Massachusetts Military Reservation

PLUME CONTAINMENT SYSTEM PROJECT EXECUTION PLAN

**RE: MEMORANDUM OF RESOLUTION FOR THE DRAFT FS-12 PLUME
CONTAINMENT SYSTEM PROJECT EXECUTION PLAN**

**Responses to Comments Dated 23 September 1996 on the
Draft FS-12 Plume Containment System Project Execution Plan (September 1996)**

FIGURE 1-2 SITE MAP OF FS-12 STUDY AREA.

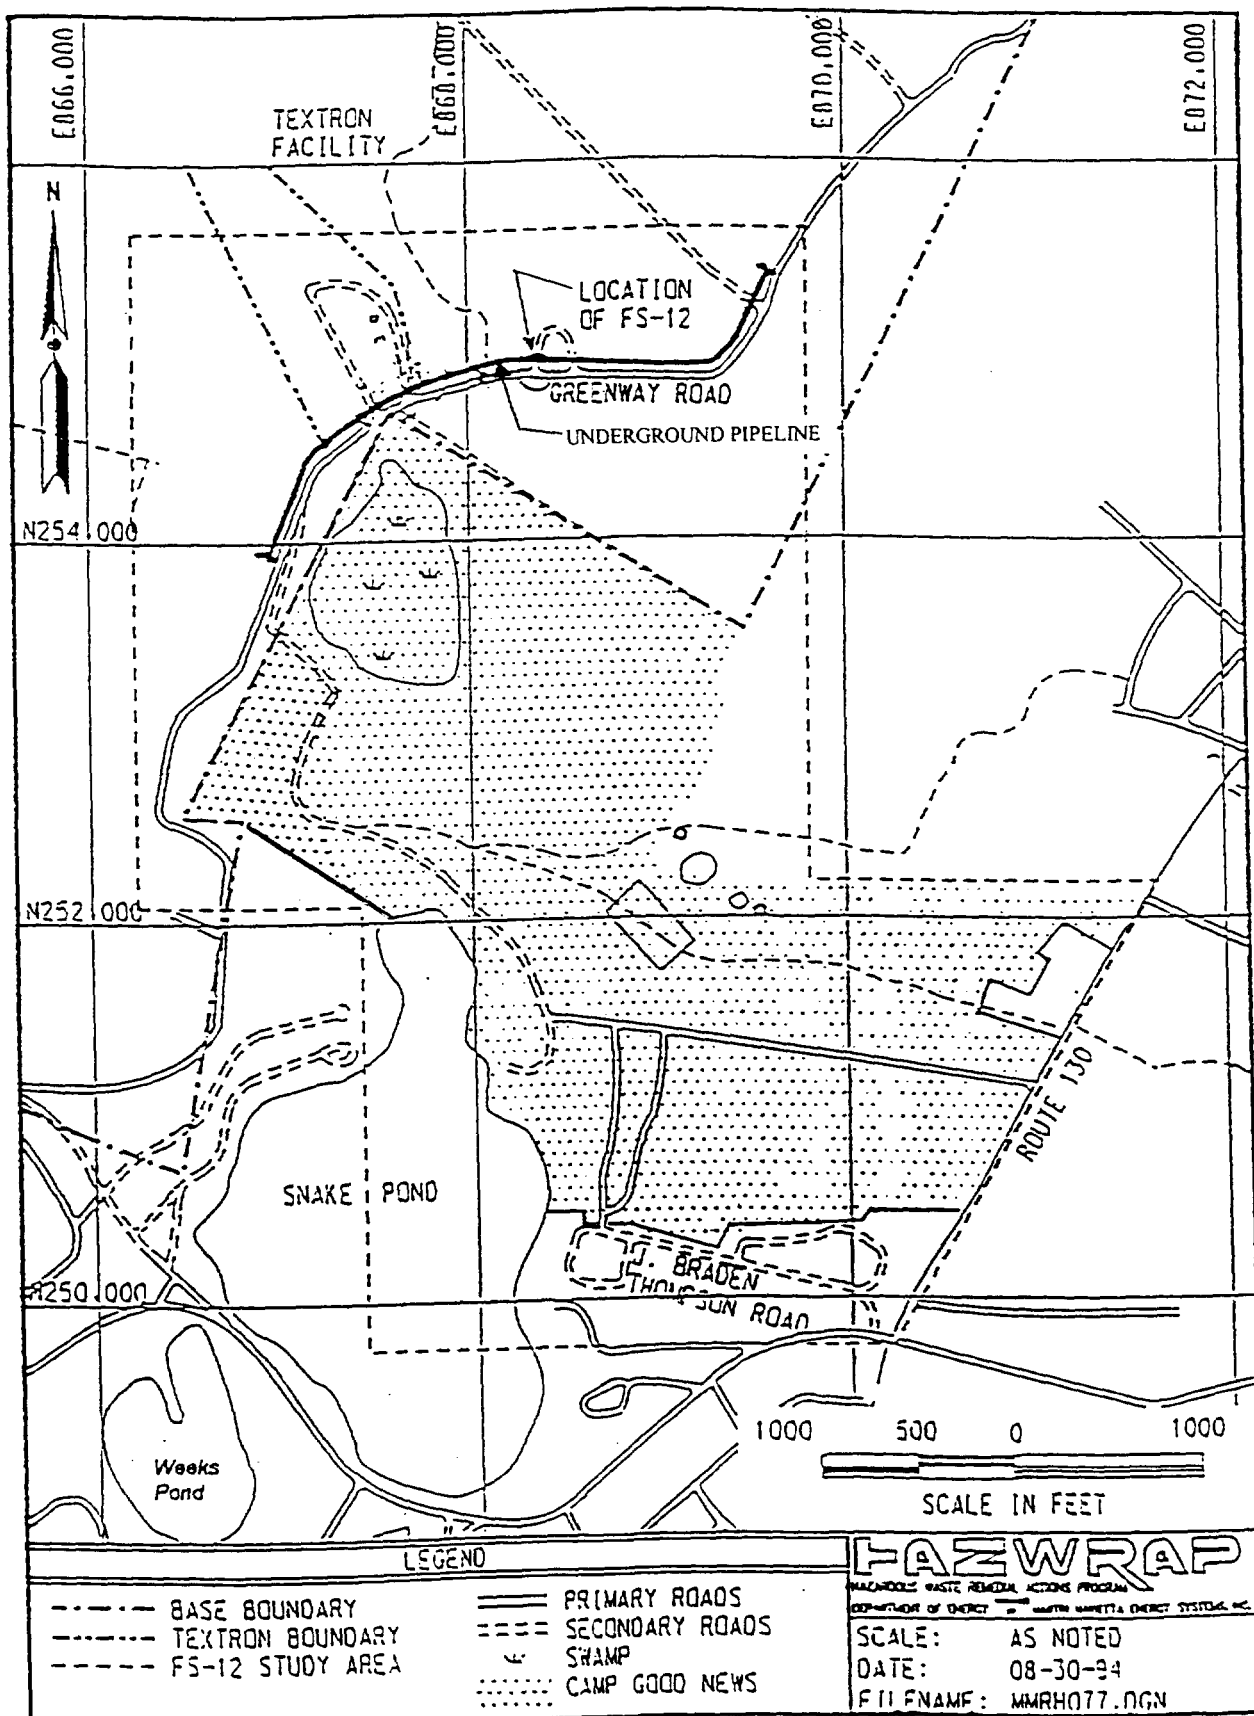
- **Comment #1, Page 1-6, Figure 1-2:** Page 1-6, Figure 1-2: Noting the wetland area designated to the North of Snake Pond, I would suggest that the Ecological Monitoring of the surrounding ecological resources include some baseline characterization of that wetland area. Perhaps it was already delineated recently. At a minimum, I would suggest the monitoring of the GMW-22 and GMW-4 to assure minimization of impact to the ecological resource. A recent USGS publication.

FUEL SPILL 12 **LOCATION OF PROPOSED EXTRACTION AND** **REINJECTION WELLS AND EDB MCL EXCEEDANCE**

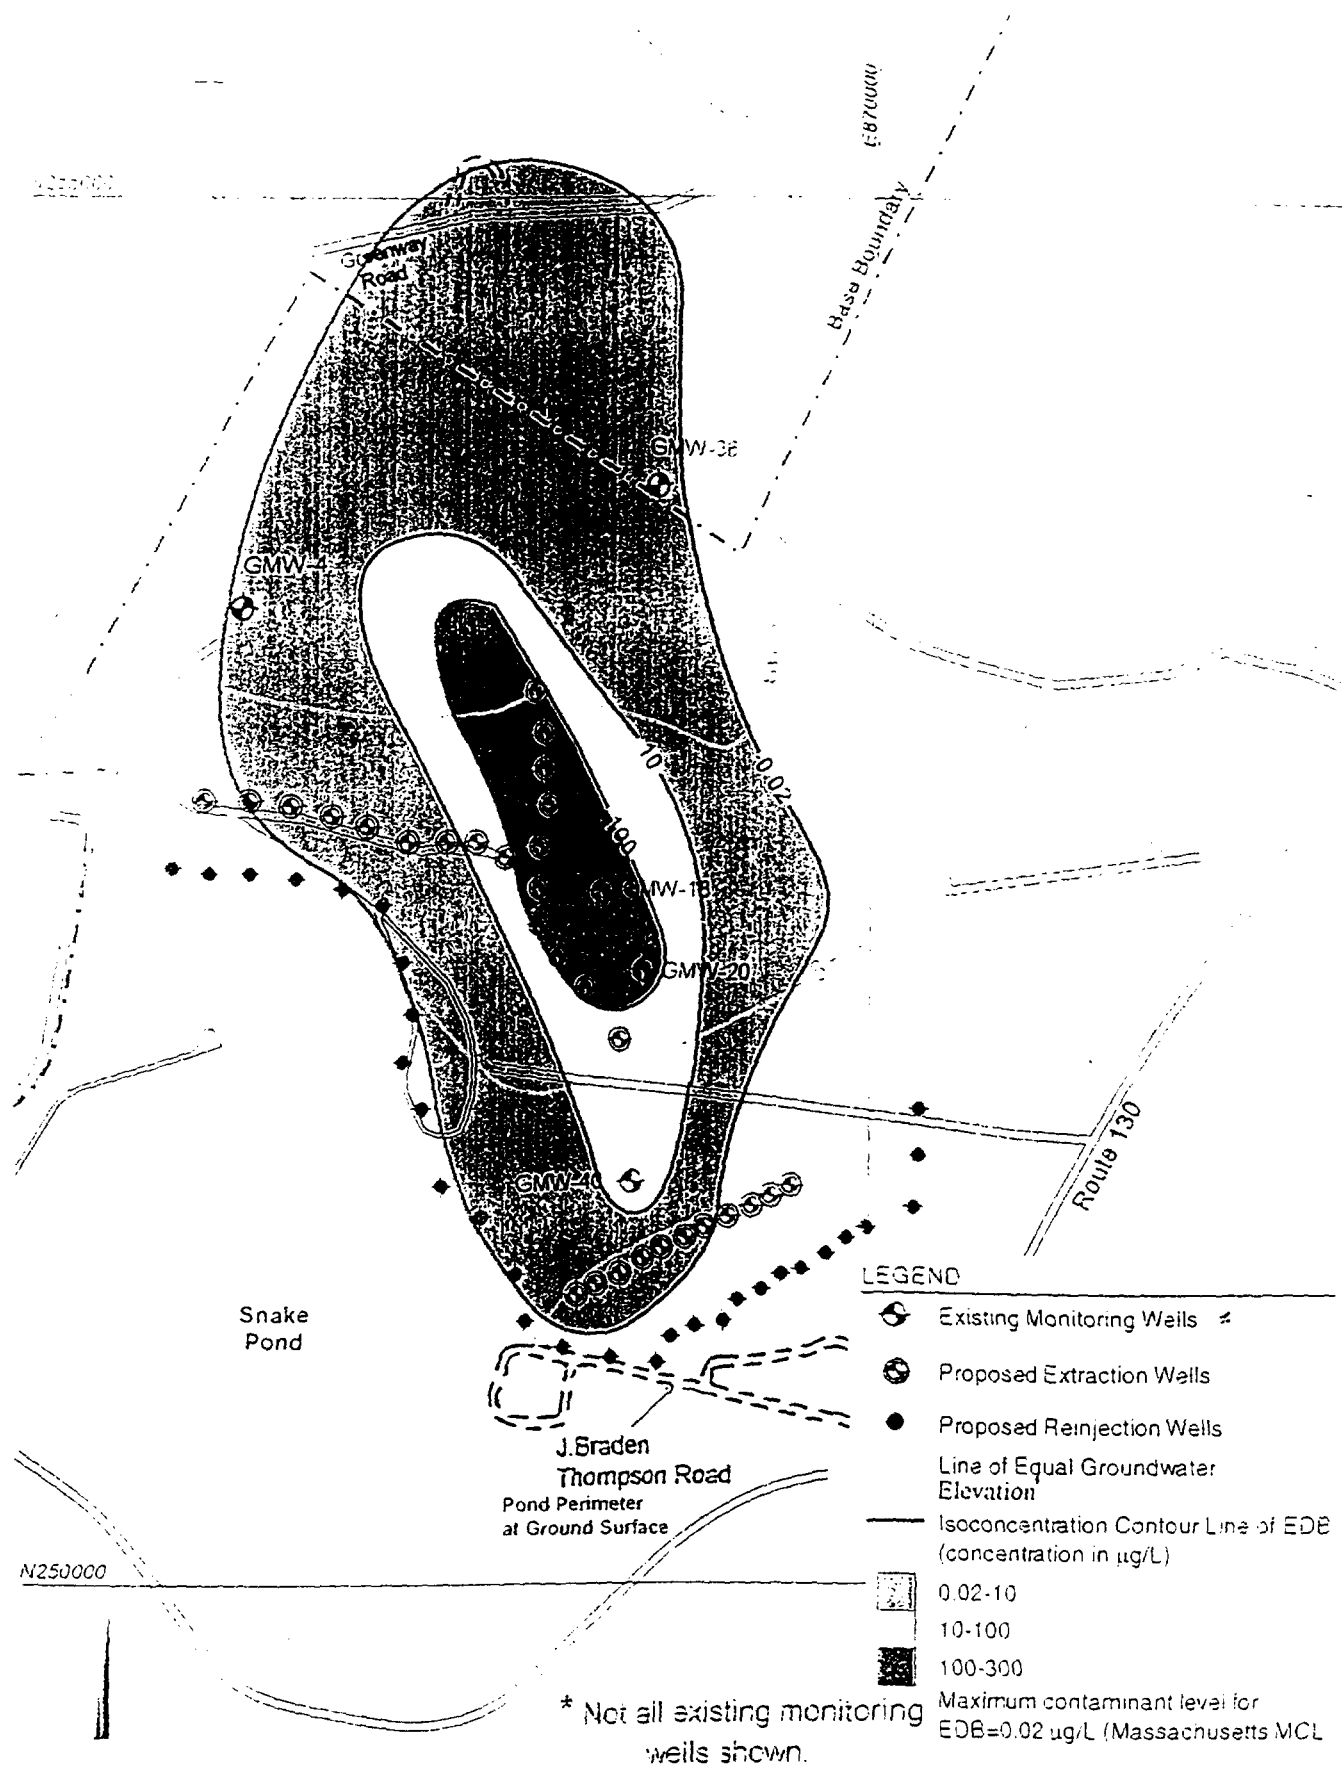
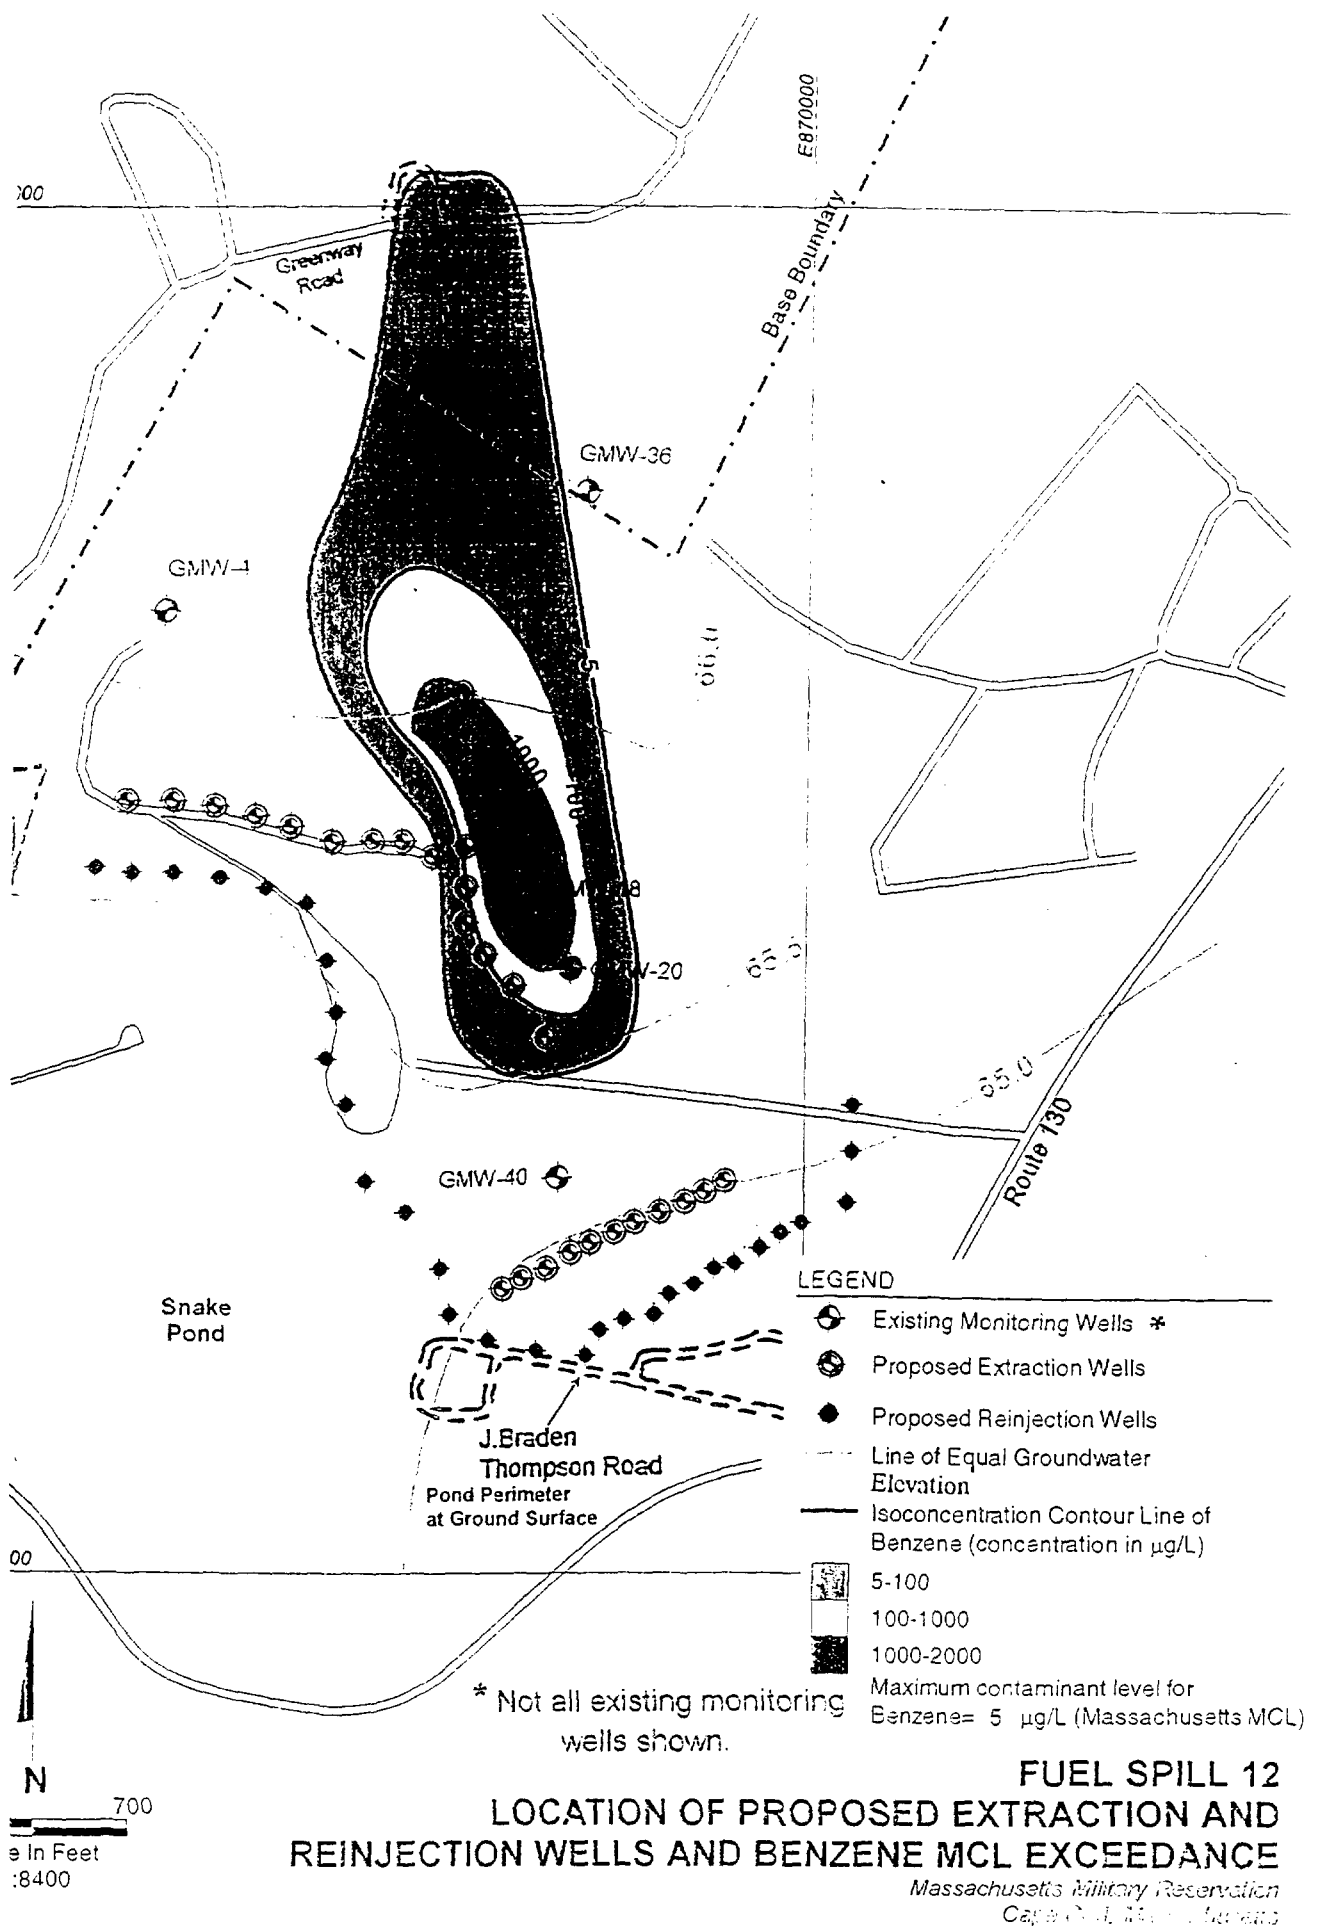
- **Comment #1, Page 3-4, para. 3.1.2:** The groundwater flows south to southeast as indicated in the text. The proposed reinjection wells that are along the west and south edges of the plume will function as a hydraulic barrier to deny the plume moving south but to southeastern. With this scenario, the proposed western extraction well locations as shown on Fig. 2-1 and Fig. 2-2, appear to be ineffective in capturing the plume.

Response: The primary purpose of the proposed reinjection wells was to minimize drawdown at Snake Pond in response to ecological concerns. The reinjection wells are not required to maintain plume capture. The western extraction fence is required to capture the EDB plume as currently defined. The significance of the western portion of the EDB plume will be assessed during the groundwater screening program discussed above. The necessity for the western extraction fence will be verified based on the screening results.

The most recent modeling simulations predict 100 % mass capture of the western portion of the plume based on the well locations as shown. Jacobs is currently in the process of performing additional model simulations, with minor modifications of the well locations (including reducing the number of wells north and east of Snake Pond), to optimize the well placement and to provide minimal impact on the ecological systems.

| Figure 3-2 FS-12 Process Flow Diagram Sheet 1 | 3-10 |

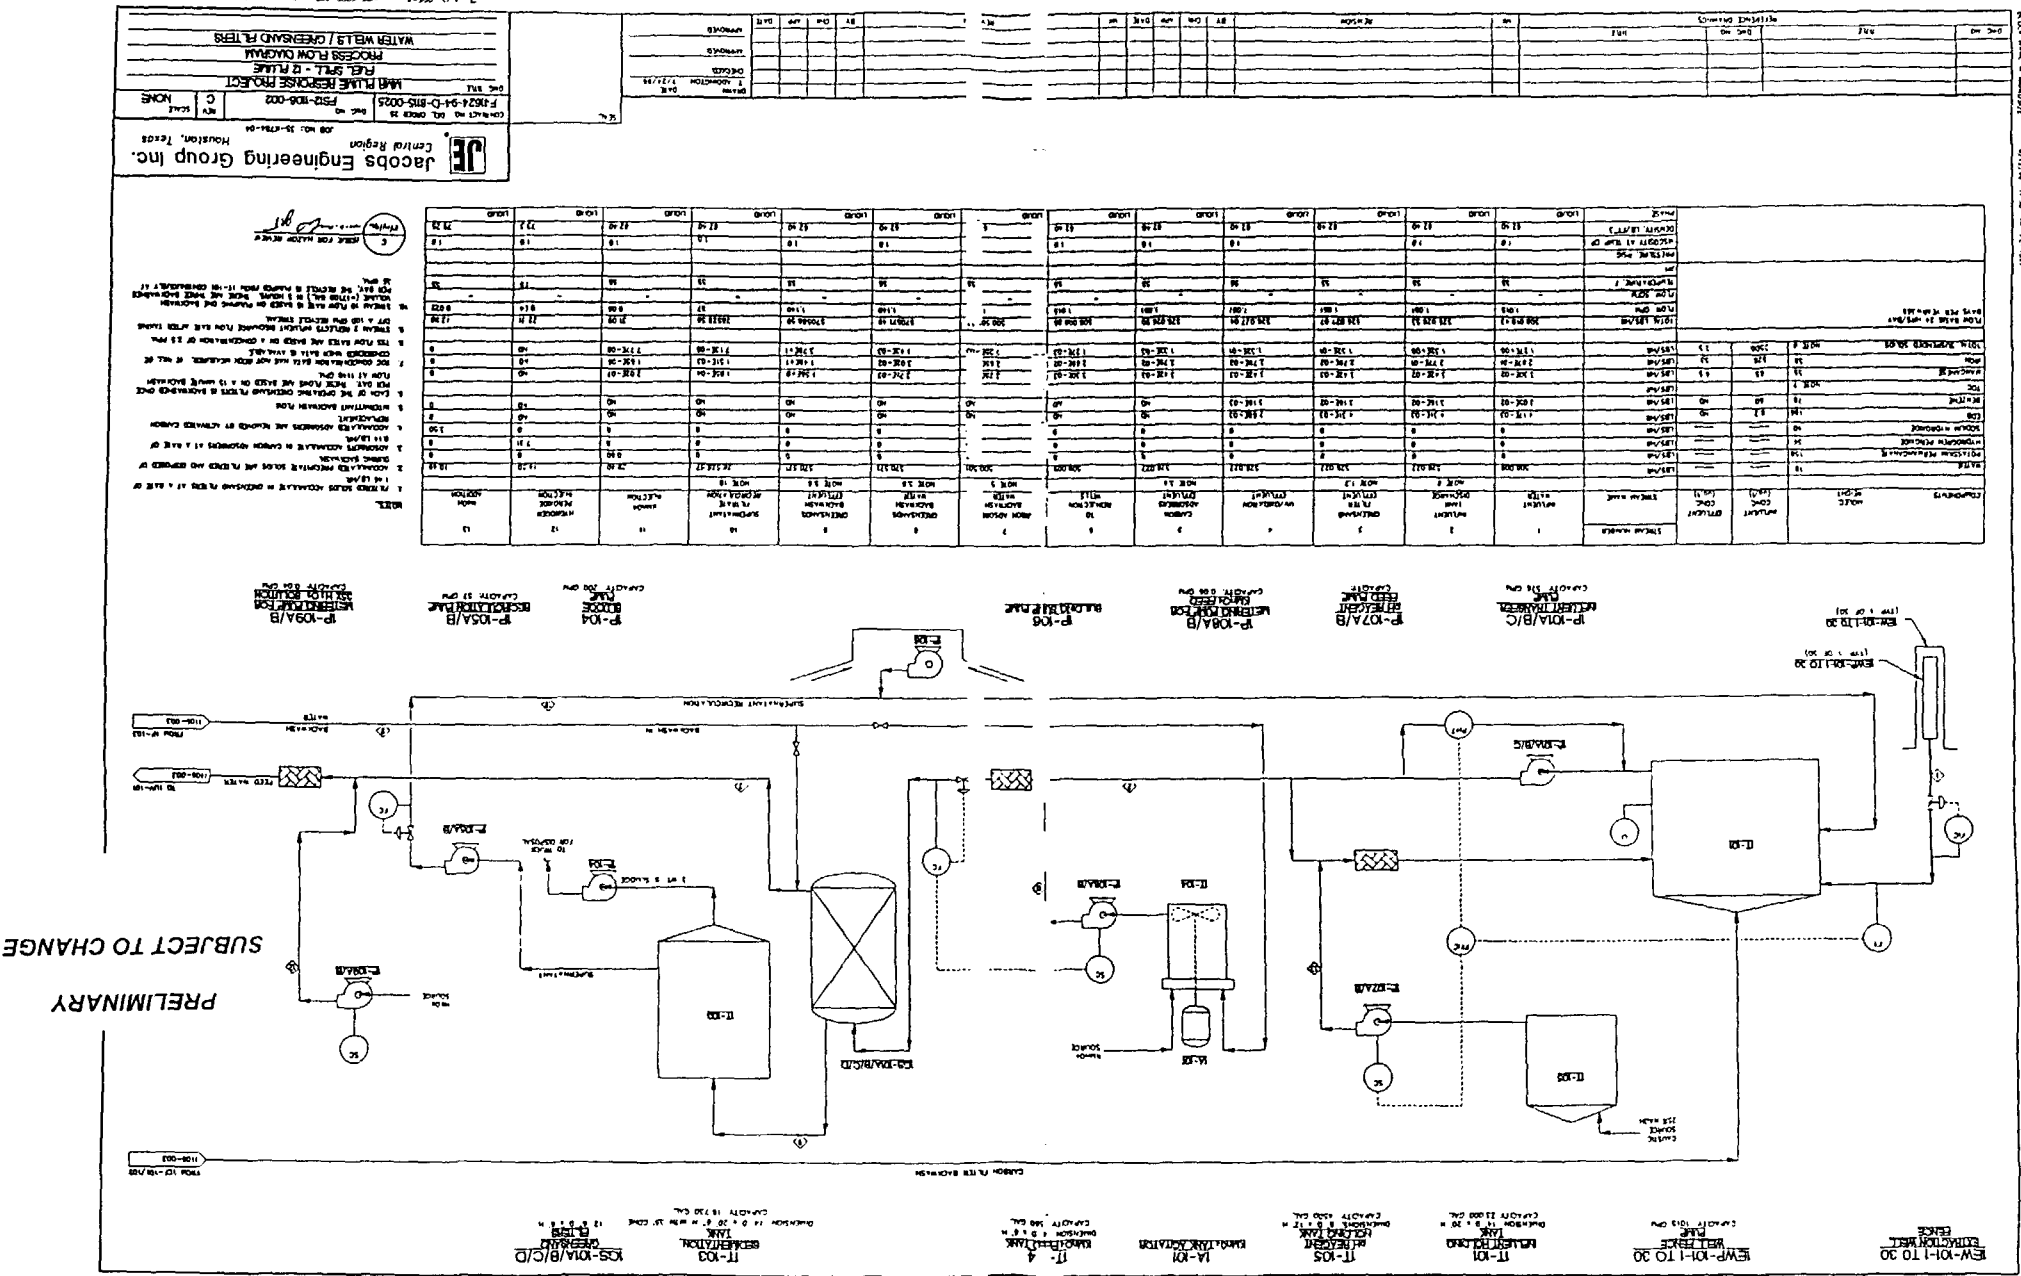
- **Comment #2, Page 3-6, Process Flow Diagram (PFD):** Please identify and express at what level of confidence on the assumptions that Jacobs used to develop the FS-12 PFDs.

- **Comment #6:** Total Suspended Solids influents are listed as 2.5 ppm in Figure 3-2 on page 3-10 of the Plan. This is a 10-fold decrease of the concentration proposed in Figure P-2 of the 60% Design (22.05ppm). Please explain this difference.

- **Comment #7:** Please specify the pH in Stream No. 2 of figure 3-2, page 3-10 of the Plan.

- **Comment #8:** Please provide a key to the various symbols and patterns used in Figure 3-2, page 3-10 of the Plan.

Response: To provide more confidence in the concentrations used as a basis for the design, Jacobs has contracted with OpTech to update their existing data base which includes the concentrations of contaminants in monitoring wells in the FS-12 and SD-5 plumes. The information in this data base will then be used to calculate "weighted average" concentrations of expected contaminants based on the specified locations of the extraction wells. The information will be used to update the PFDs in the Final Design Package.

Response: The pH in Stream No. 2, Figure 3-2, will be provided.
